**GULF STATES UTILITIES COMPANY**

River Bend Station - Unit 1  
Docket No. 50-458

Enclosed for your review is the Gulf States Utilities Company response to the request for additional information identified by the Nuclear Regulatory Commission's Power Systems Branch regarding the Division III compliance to Branch Technical Position PSB-1 and updating Final Safety Analysis Report (FSAR) Figure 8.3.3 for second level undervoltage for the Division III 4.16 kV bus. Attachment 1 provides revisions to the FSAR which will be included in a future amendment. Attachment 2 provides revisions to the River Bend Station Technical Specifications which are necessary to ensure consistency with the FSAR.

**FIGURE 8.3-3**

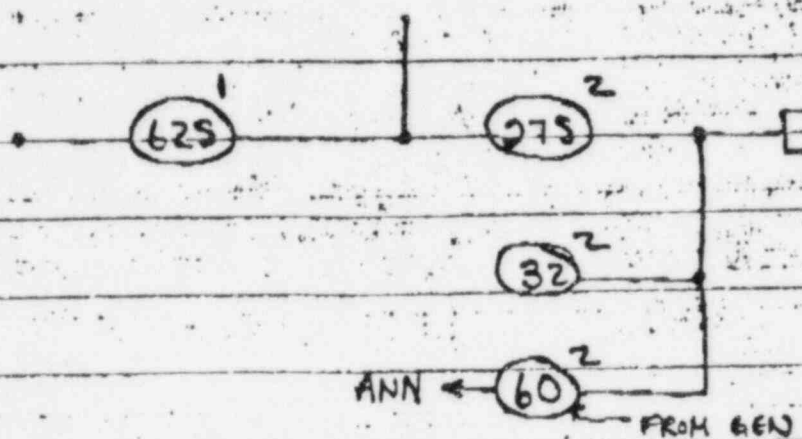
INSERT A

INSERT B

BLOCK TRIPPING

OF 61V, 40 &amp; 67/51
